SERVICE BULLETIN 112

MAINTENANCE PROCEDURE FOR THE TESTING AND REPLACEMENT OF HOOK
AND PILE TAPE USED TO SEAL THE PERIMETER OF THE DEFLATION CAP
IN FLIGHT

AMENDMENT NO. 146

ENVELOPE, S-50 A

SHEET 10
VIEW PT

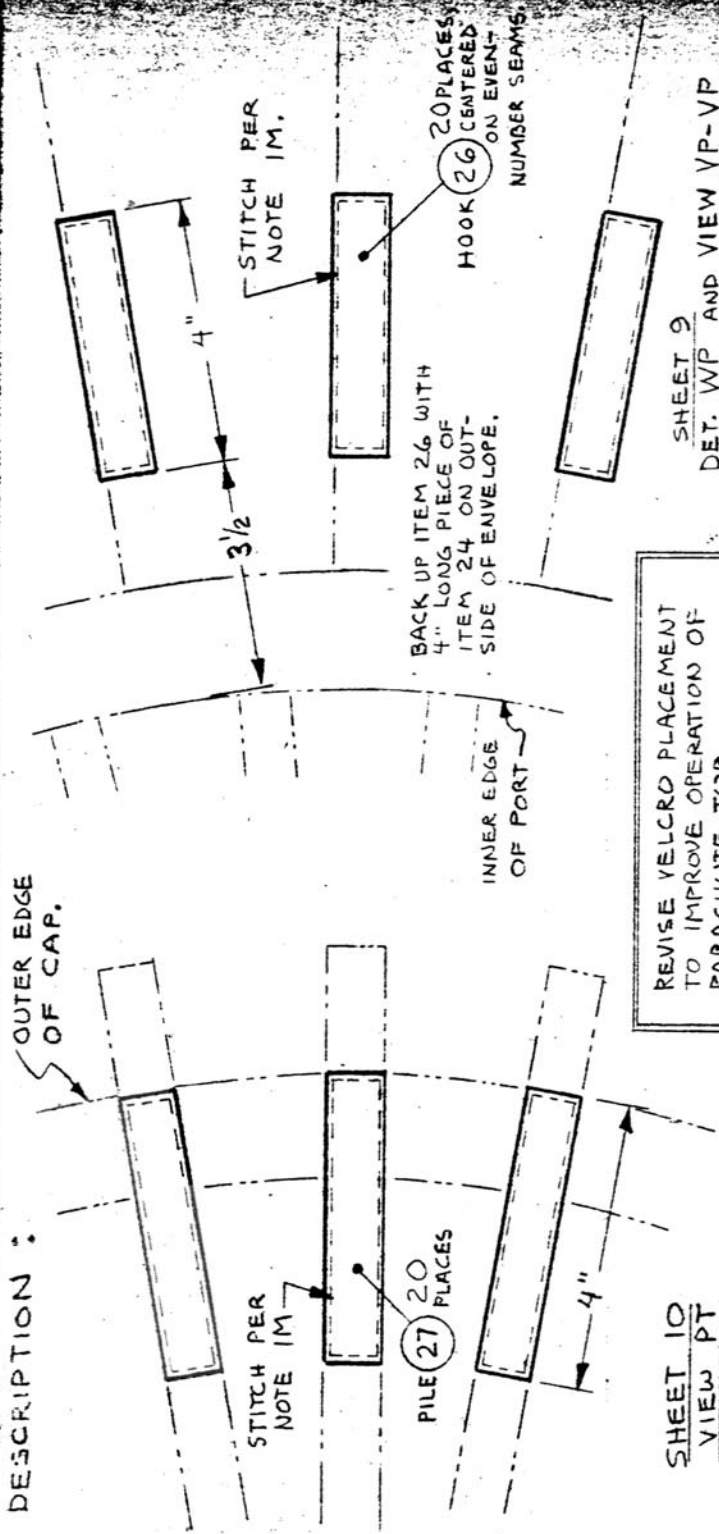
SHEET 9
DET. WP AND VIEW VP-VP

REVISE VELCRO PLACEMENT TO IMPROVE OPERATION OF PARACHUTE TOP
MAJOR CHANGE
(REF. DR 8604)
